Neff Hall - HVAC Upgrades Phase 2

ADDENDUM #02

TO CONTRACT DOCUMENTS FOR: Project #CP – 231442

DESIGNED	MHB	DRAWN	MHB
FIELD	FIELD BOOK		
CHECKED	JAK	CHECK DATE	02/09/24
SHEET TITLE			
BASEMENT LOW VOLTAGE PLAN			
PROJECT NO. CP231442			
DRAWING ISSUED DATE: 03/07/24			
SHEET			
E105

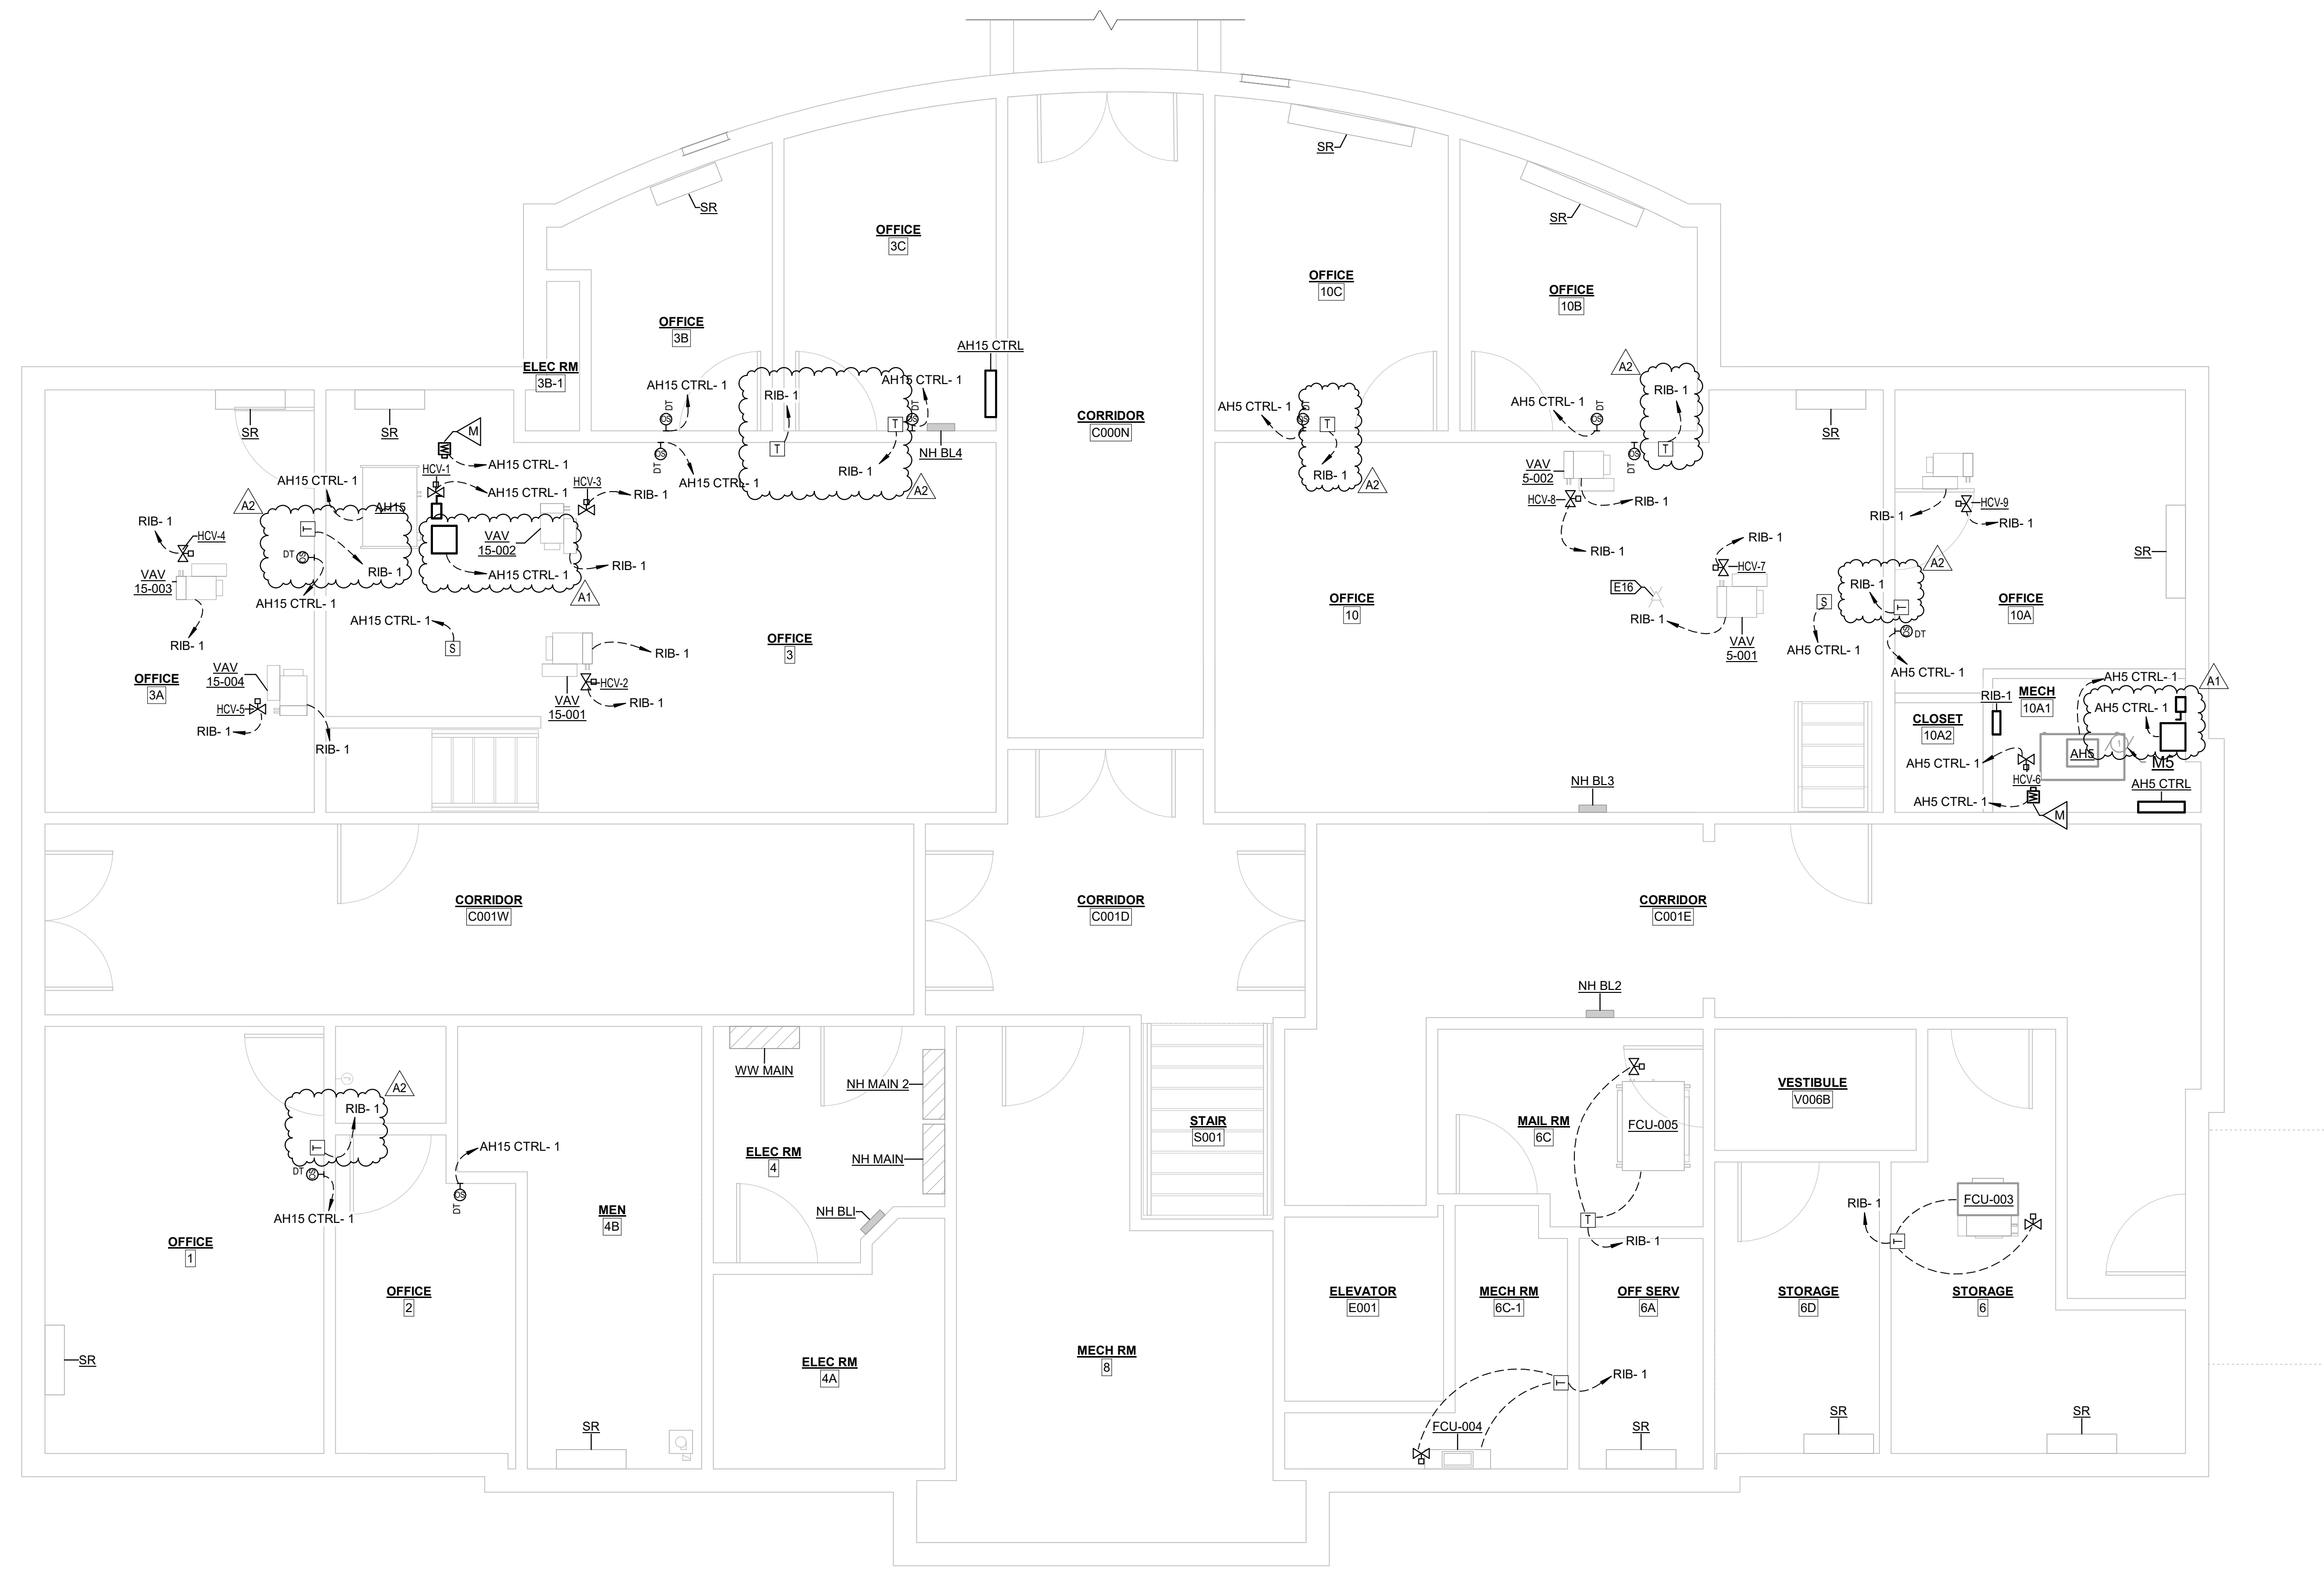
- 1) Drawing Sheet E105 Cover Sheet, **REVISE** Office 1, Office 3, Office 3A, and Office 3C thermostat power supply from AH15 CTRL-1 to RIB-1.
- 2) Drawing Sheet E105 Cover Sheet, **REVISE** Office 10, Office 10A, and Office 10C thermostat power supply from AH5 CTRL-1 to RIB-1.
- 3) Drawing Sheet E106 Cover Sheet, **REVISE** Office 103, Office 104, Conference 105, Office 107, and Corridor C101W thermostat power supply from AH4 CTRL-1 to RIB-2.
- 4) Drawing Sheet E106 Cover Sheet, **REVISE** Lounge 108, Office 110, Office 119, Office 102, Office 121, and Office 122 thermostat power supply from AH11 CTRL-1 to RIB-2.
- 5) Drawing Sheet E107 Cover Sheet, **REVISE** Office 200A and Office 202 thermostat power supply from AH9 CTRL-1 to RIB-3.

DESIGNED	MHB	DRAWN	MHB
FIELD	MHB	FIELD BOOK	
CHECKED	JAK	CHECK DATE	02/09/24
SHEET TITLE			
SECOND FLOOR LOW VOLTAGE PLAN			
PROJECT NO. CP231442			
DRAWING ISSUED DATE: 02/09/24			
SHEET			
E107

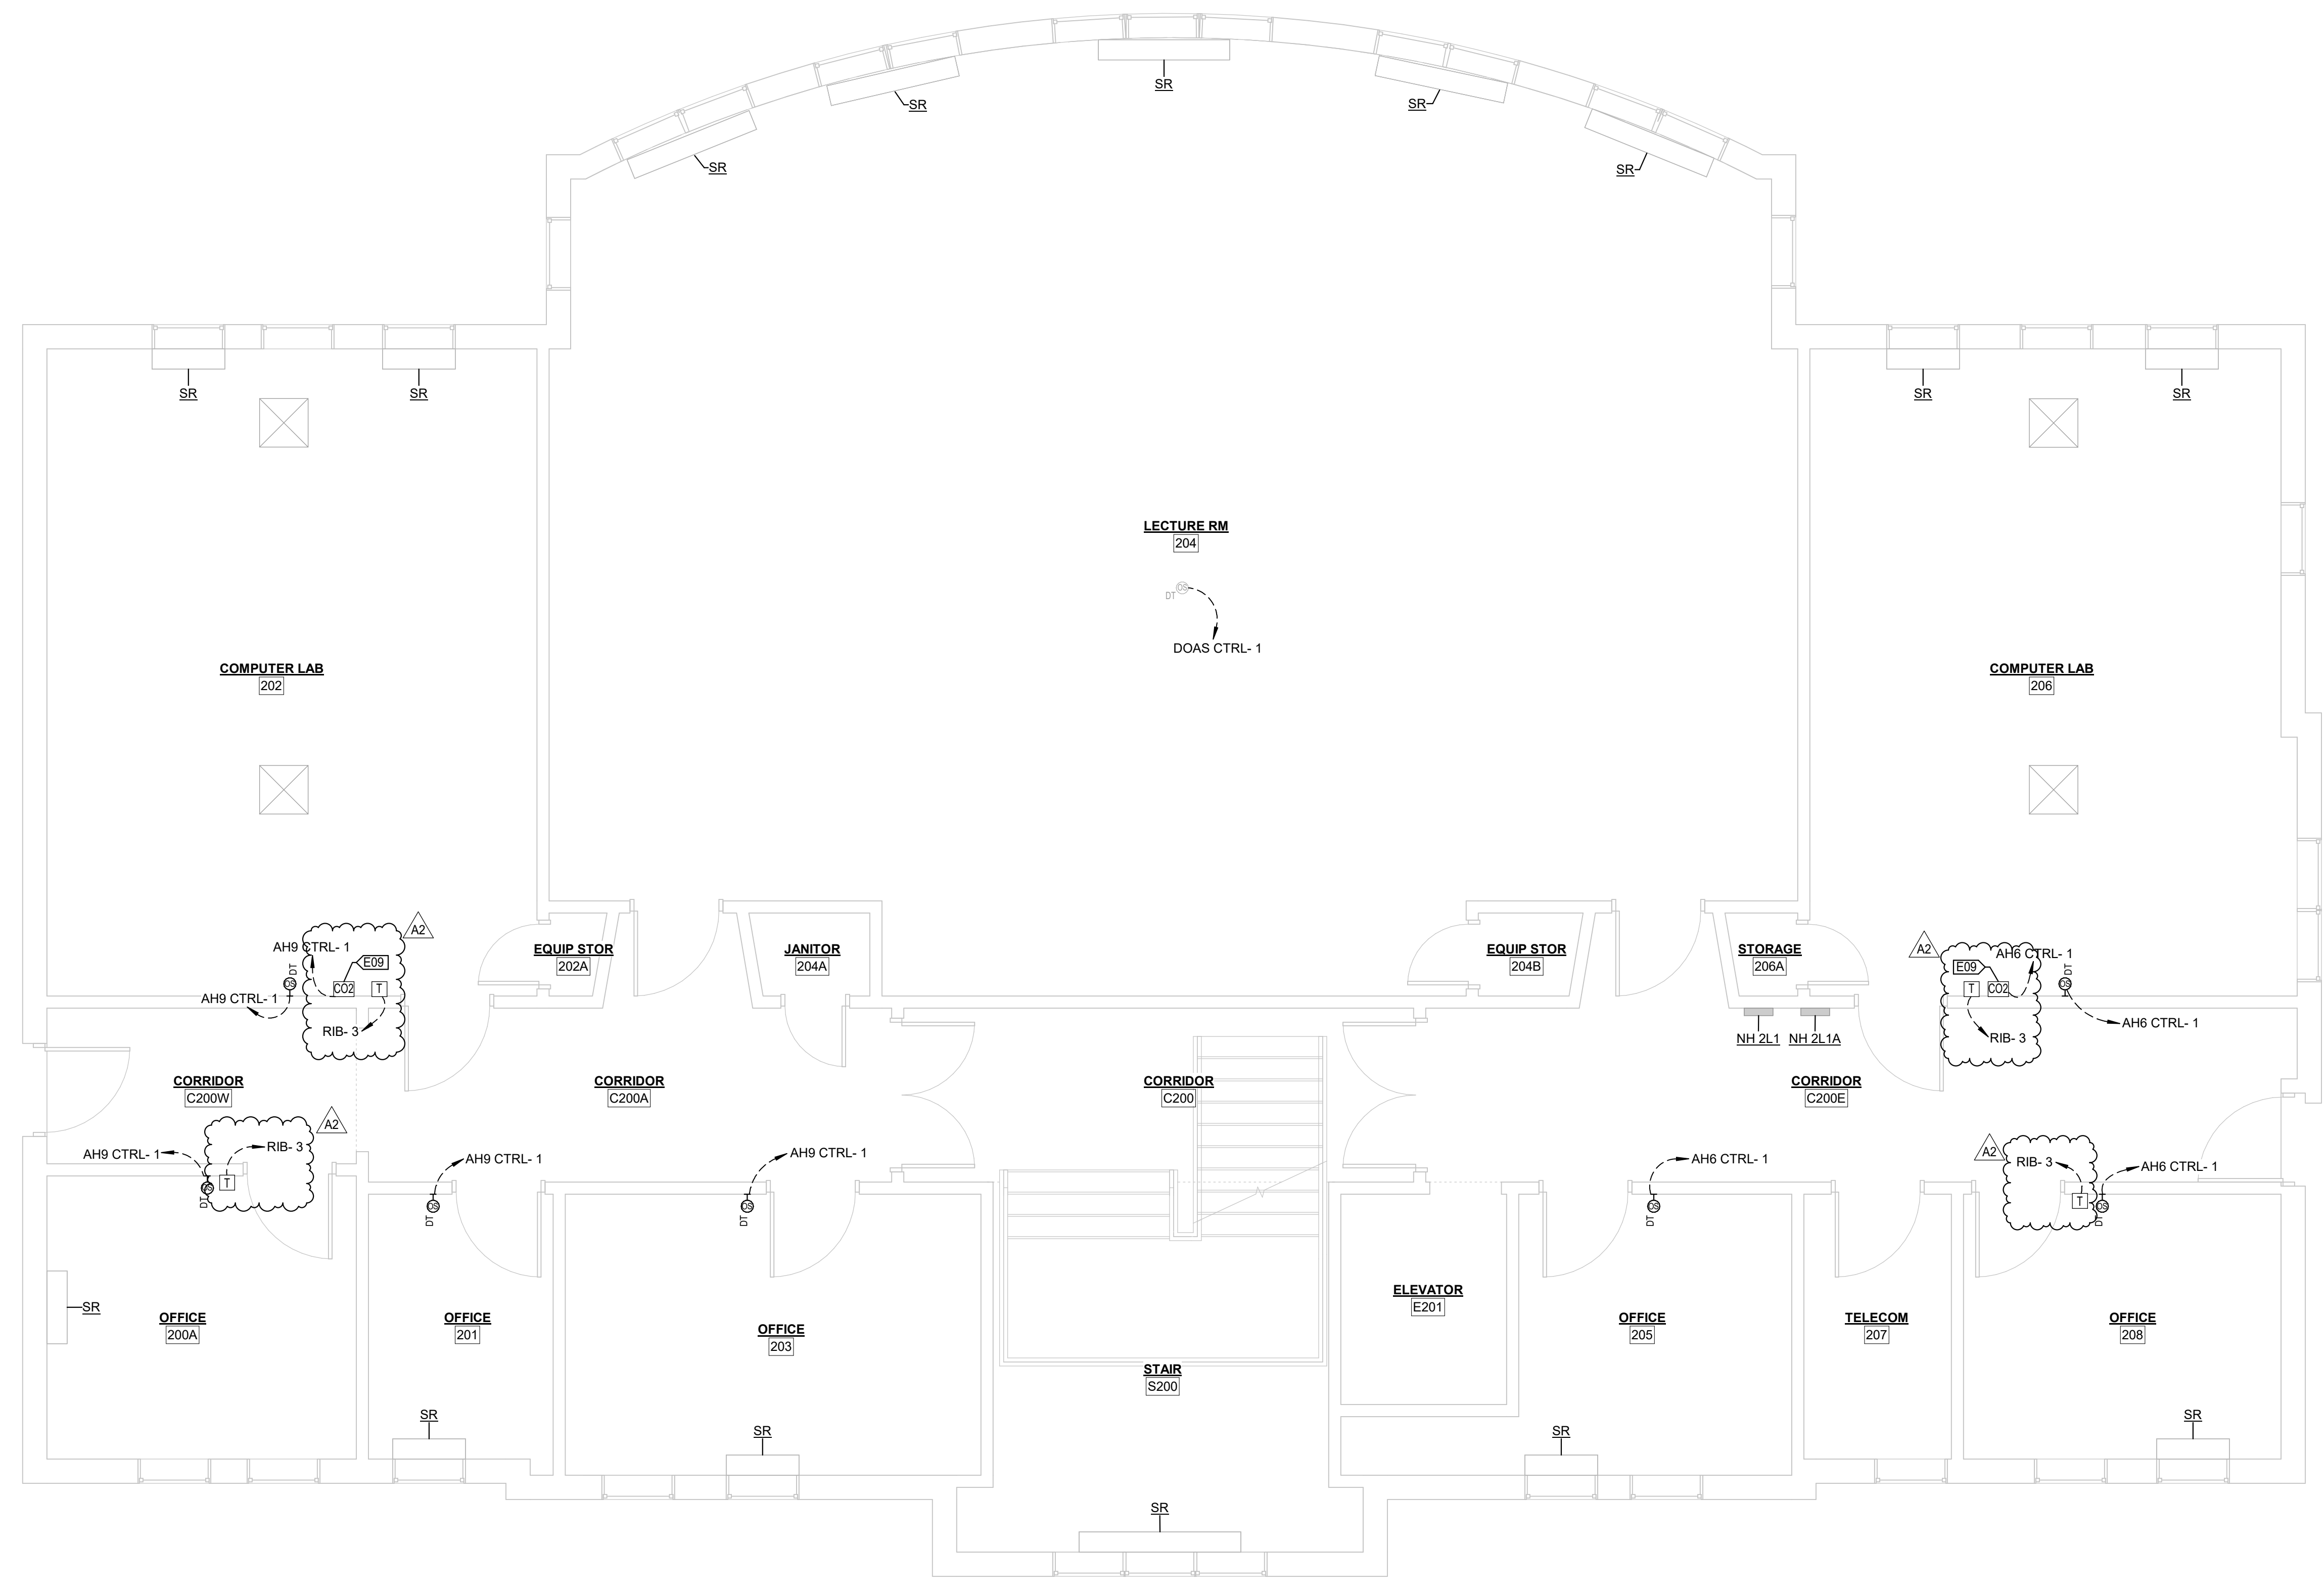
- 6) Drawing Sheet E107 Cover Sheet, **REVISE** Office 206 and Office 208 thermostat power supply from AH6 CTRL-1 to RIB-3.
